Access Compliance Report

Public Rights-of-Way

(Curb Ramps)

Intersection ID: N/A	Main Street: TRAILMOOR_RD	Cross Street: BRECKFIELD_CT	Location: W
ADA ID: 7BBE3A8A615A	Ramp Type: PerpDiag	Initial Pass/Fail: Fail	Overall Compliance: No
Codes/Mitigation Info/Possible Solution		Field Measurements/Component Compliance	
Severity Score: 8.75

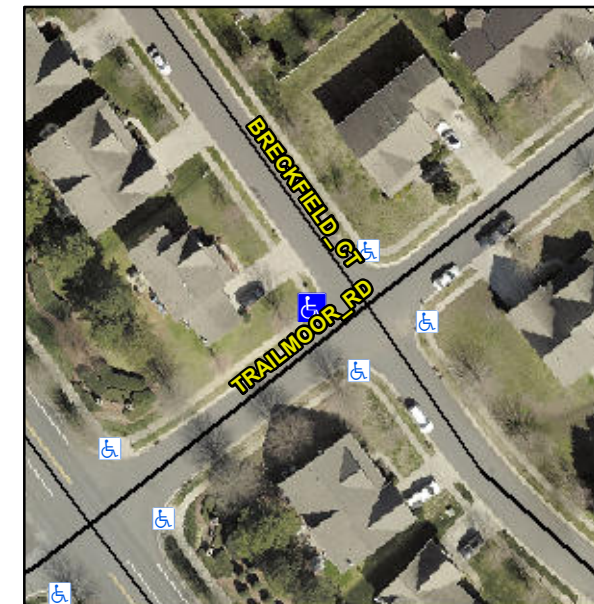
R304.5.1

Compliance	Description	Data	Compliance	Description	Data
N/A	Ramp Length (in)	49.0	Yes	Ramp Slope (%)	5.4
No	Ramp Width (in)	42.0	Yes	Ramp XSlope (%)	0.2
N/A	Flare Type LT	N/A	N/A	Flare Type RT	N/A
N/A	Flare Slope LT (%)	N/A	N/A	Flare Slope RT (%)	N/A
N/A	Flare Traversable LT?	N/A	N/A	Flare Traversable RT?	N/A
N/A	Landing Length (in)	N/A	N/A	DWS Provided?	N/A
N/A	Landing Width (in)	N/A	N/A	DWS Contrast?	N/A
N/A	Landing Slope (%)	N/A	N/A	DWS Length (in)	N/A
N/A	Landing X Slope (%)	N/A	N/A	DWS Full Width?	N/A
N/A	Landing Curb? (Y/N)	N/A	N/A	DWS Offset (in)	N/A
N/A	Shared Landing?	N/A			
N/A	Gutter Ponding?	N/A	N/A	Gutter Slope (%)	N/A
N/A	Gutter Lip Ht (in)	N/A	N/A	Gutter X Slope (%)	N/A
N/A	Painted X Walk1?	No	N/A	Painted X Walk2?	No
	X Walk 1 Direction	To SE		X Walk 2 Direction	To NE
N/A	X Walk 1 Width (in)	N/A	N/A	X Walk 2 Width (in)	N/A
	X Walk 1 Slope (%)	1.6		X Walk 2 Slope (%)	4.6
	X Walk 1 X Slope (%)	2.4		X Walk 2 X Slope (%)	2.6

Remove & Replace Curb Ramp With Two New Directional Ramps or Equivalent.
